Authors' Responses to the Comments of Malek Alshorman (Referee)

hess-2019-28R1

Scenario-based inundation analysis of metro systems: a case study in Shanghai Hai-Min Lyu, Shui-Long Shen, Jun Yang, and Zhen-Yu Yin

Figure 2: Calculated subcatchment and grid in SWMM and GIS: (a) drainage capacity and flow direction of each subcatchment; (b) calculated grid of each subcatchment

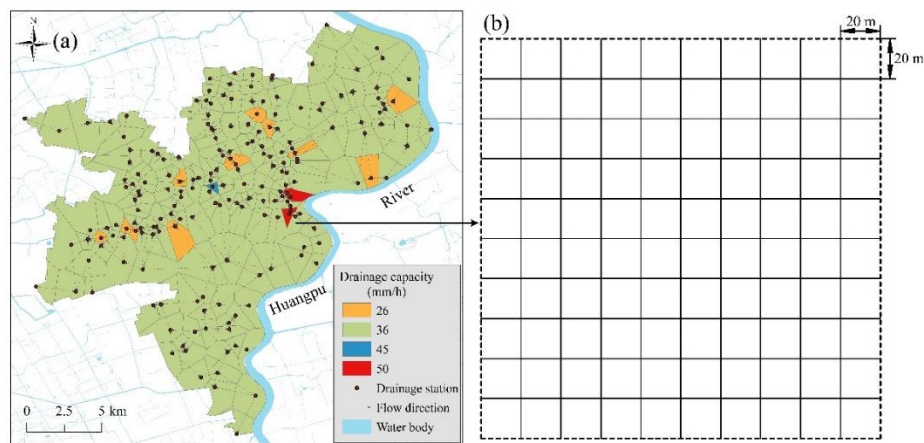
-page 17, figure-6: are you consider the existing drainage network in the modeling? if yes you have to show that in the text it no you have to consider it because it will have a significant effect.

Answer: Thanks for the reviewer's constructive comment. We agree that the drainage network has significant effects on simulated results. Indeed, we haven't modelled the existing drainage network directly. It is difficult to consider the drainage network directly in the model since the drainage network data is difficult to collect in such a large study area with 120 km². Thus, if model each drainage, the calculation in such large area become time consuming. To solve this problem, we use the capacity of drainage station to reflect the function of drainage network. Fig. 2 shows the capacity of drainage station. In this model, we suppose that the rainwater is flowed from one subcatchment to another. During surface flowing, the rainwater is redistributed between ground surface and drainage station. The water quantity calculated by SWMM model is reduced by corresponding drainage capacity of each subcatchment (see Fig. 2). The reduced water quantity of each subcatchment was used to redistribute in the algorithm modelling. Moreover, we use a spreading coefficient to express the spreading process. The spreading coefficient is used for moving runoff between neighbor subcatchments. We have revised this section from line 14 to line 16 in page 8, and we have added discussions of limitations for the proposed approach from line 10 to line 15 in page 23, and line 1 to line 3 in page 24.

Moreover, the function of drainage network is reflected by the drainage capacity of each drainage station (see Fig. 2). The water quantity of each subcatchment calculated in SWMM is reduced by the capacity of the drainage station.

drainage station. The limitation of the integrated approach is that the existing drainage network has not been directly considered during simulation, since the complexity of the drainage network in a regional scale. Alternatively, the capacity of the drainage station (see Fig. 2) is used to reduce the water quantity of each subcatchment calculated in SWMM. The function of drainage network is reflected by the drainage capacity of each drainage station.
